STAFF REPORT

Meeting Date: November 15, 2016
To: Honorable Mayor & City Council
From: Aaron Kunz, Deputy Director of Transportation
Subject: Consideration of Fehr & Peers Evaluation of Crosswalk Treatments
Attachments: 1. Beverly Gardens Park Renderings
2. Fehr & Peers Memorandum – Pedestrian Crossing Evaluation

MEMORANDUM

Subject: Pedestrian Crossing Evaluation

Figure 9
Rodeo Drive to Crescent Drive

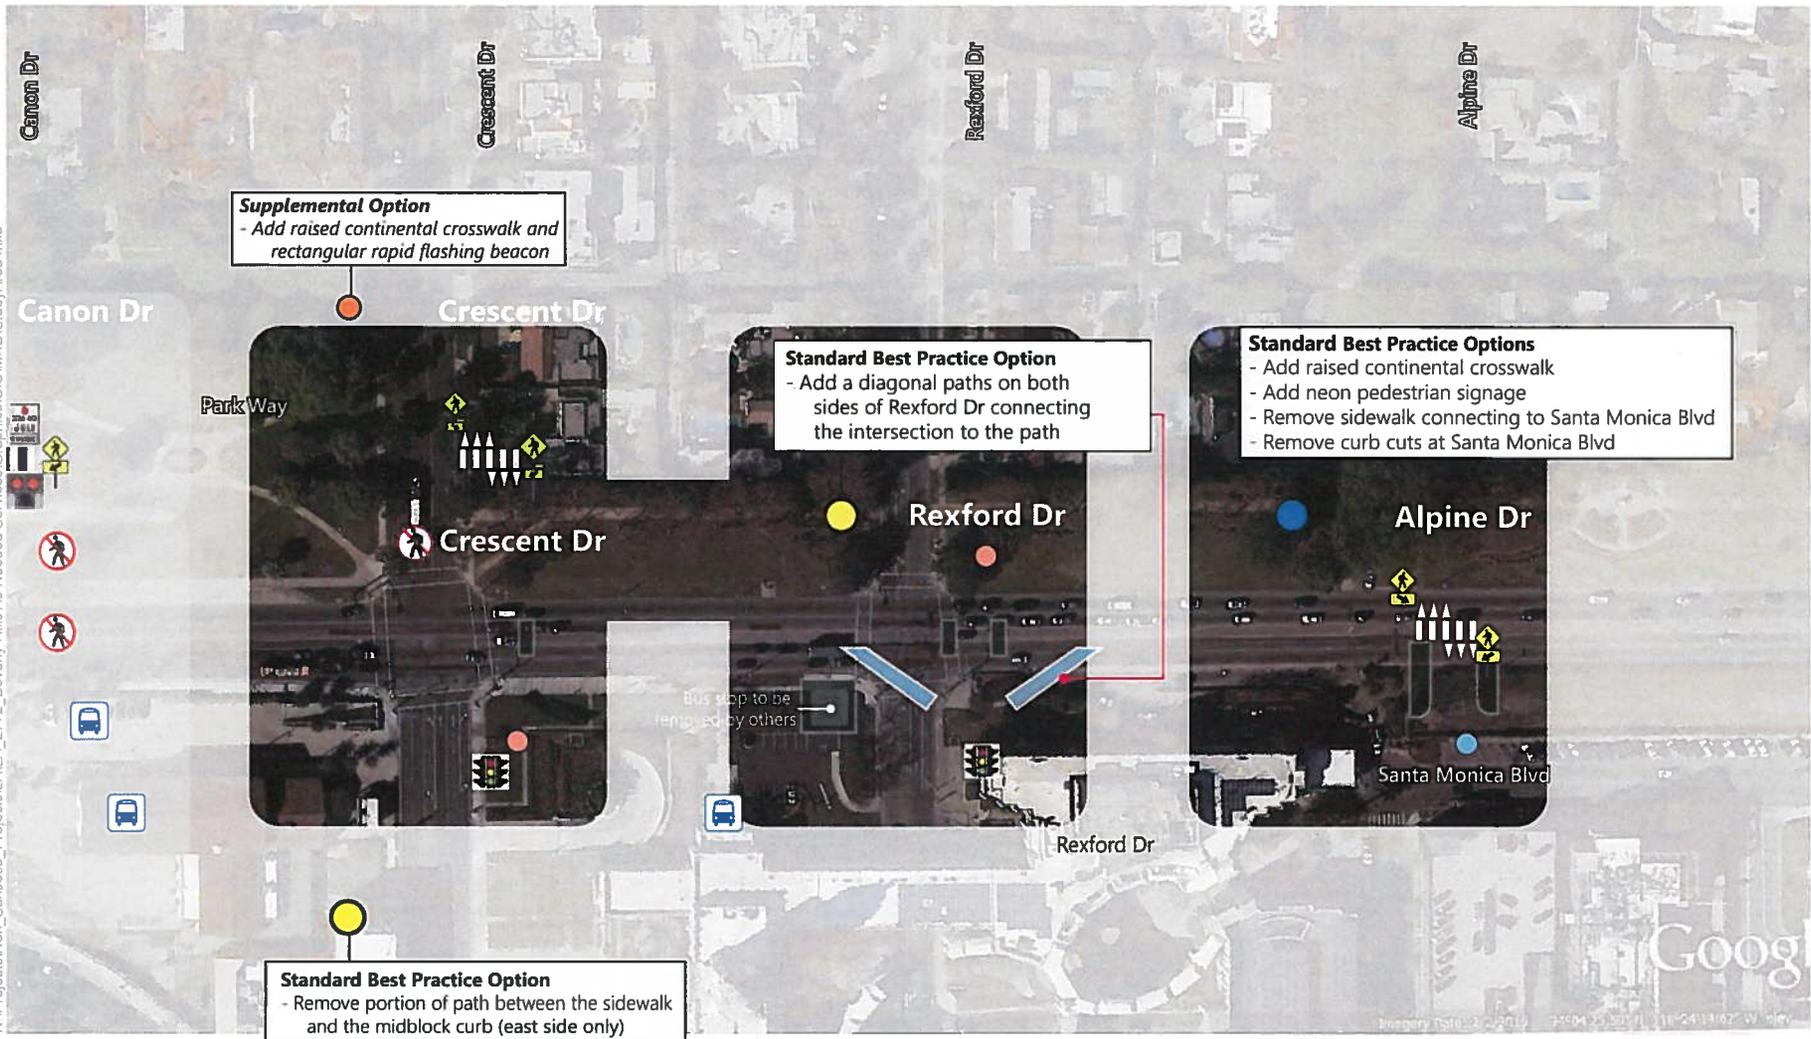
Traffic & Parking Commission Question: *Consider scaling proposal back to rectangular rapid flashing beacon's along Park Way.*

Traffic & Parking Commission Question: *General concern about motorist compliance with pedestrian hybrid beacons along Park Way.*

Answer: Under existing conditions, the crosswalks along Park Way are not marked. Legally, pedestrians can cross unless a sign is posted otherwise. Signs are specifically posted at Rodeo Drive prohibiting crossings across the south side of Park Way, although our observations indicate that crossings are taking place here. Motorists are required to yield to pedestrians in a marked or unmarked crosswalk at an intersection, and pedestrians have the duty of using due care for his or her safety (California Vehicle Code section 21950). Because the crossings are uncontrolled and unmarked, it is likely that pedestrians now cautiously wait for a gap in traffic before crossing.

The installation of a rectangular rapid flashing beacon system would not change the legal traffic control conditions at these crossings. Motorists would still be required to yield to pedestrians, and pedestrians would still have the duty of using due care for his or her safety. The purpose of the flashing lights is solely to bring the driver's attention to the presence of a pedestrian. With the installation of a rectangular rapid flashing beacon system, pedestrians may choose to activate the lights using the push button and immediately cross upon activation without waiting for a gap. This will have an effect on vehicle operations, particularly given the high pedestrian activity in this area, as there could be fairly regular activations during peak periods. For this reason, pedestrian hybrid beacons are preferred in high pedestrian activity areas. With a pedestrian hybrid beacon, pedestrians would have an Upraised Hand indication (symbolizing don't walk) until such time as when the vehicle phase is green for Santa Monica Boulevard and red for the cross streets (Rodeo Drive, Beverly Drive, and Canon Drive) that also intersect the subject crosswalks. This would minimize the impact on vehicle flow on these streets. Furthermore, the pedestrian hybrid beacon provides a controlled crossing for pedestrians, so this option optimizes pedestrian safety.

Answer: While pedestrian hybrid beacons (also know as a HAWK signal) are a less known traffic control device in this area, they are an approved device in the federal and the California Manual on Uniform Traffic Control Devices. They were developed and first deployed in Tucson, Arizona starting in 2000. It was considered an experimental treatment since it had not yet been approved by the Federal Highway Administration, but it was later adopted in 2009. A study was published in 2006 documenting a 97% motorist compliance rate (i.e., yielding or stopping where required) at existing pedestrian hybrid beacons (Improving Pedestrian Safety at Unsignalized Crossings, Publication TCRP report 112/NCHRP report 562, 2006). A study published by the Federal Highway Administration in 2010 demonstrated a 69% reduction in pedestrian crashes where PHB's had been installed (Safety Effectiveness of the HAWK Pedestrian Crossing Treatment, FHWA-HRT-10-042, July 2010). It is recognized, however, that new installations in an area not yet accustomed to this traffic control device should be accompanied by education and enforcement campaigns. Many agencies have developed flyers that illustrate the use of the pedestrian beacon.

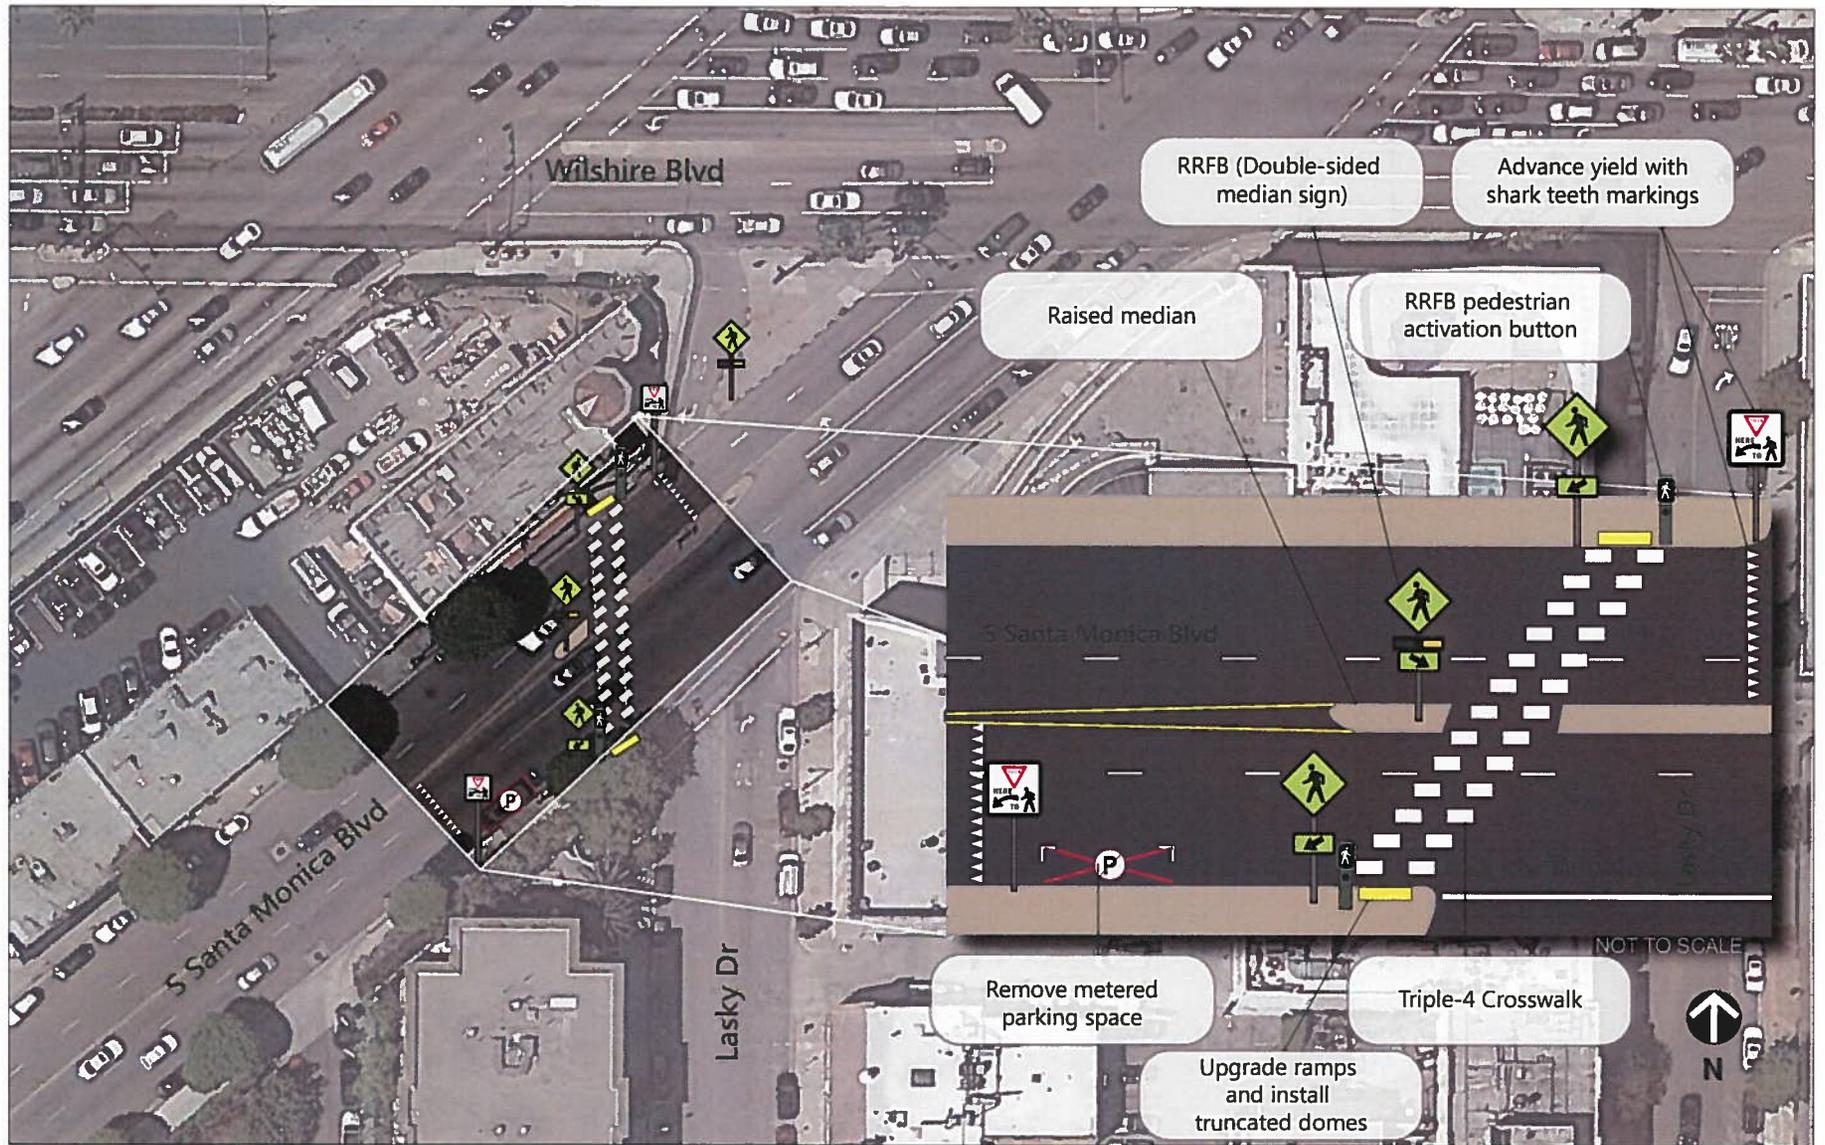
Traffic & Parking Commission Question: *Is the shark's teeth yield line enforceable?*

Traffic & Parking Commission Question: *Examine possibility for additional improvements on South Santa Monica Boulevard between Lasky Drive and Wilshire Boulevard to address weaving issues and defacto third eastbound lane.*

Answer: California Vehicle Code section 21461(a) includes a general provision that drivers must obey all regulatory signs and devices that are approved by the California Manual on Uniform Traffic Control Devices. As such, the shark's teeth yield lines are enforceable, because pavement markings are considered an official traffic control device. It is advisable, however, to accompany the markings with a "Yield Here to Pedestrians" regulatory sign to bring more attention of this legal requirement to motorists. The full California Vehicle Code paragraph reads as follows:

Answer: One option that was considered is the construction of a curb extension (i.e., corner bulb out) on the southwest corner of South Santa Monica Boulevard/Lasky Drive to prevent motorists from using the parking lane as a defacto third eastbound lane. Given the acute angle of this intersection, however, this would make it difficult for most vehicles to complete a right turn at this corner. The improvement would need to be accompanied by a right-turn prohibition. Because left turns are not allowed from westbound South Santa Monica Boulevard onto Lasky Drive, this would essentially turn the portion of Lasky Drive between South Santa Monica Boulevard and Durant Drive into a one-way street northbound with the exception of southbound access at the mid-block driveways. Because this would significantly limit circulation and access in the area, a preferred alternative would be to paint a shoulder edge line and hatching to discourage the use of this space as a third travel lane.
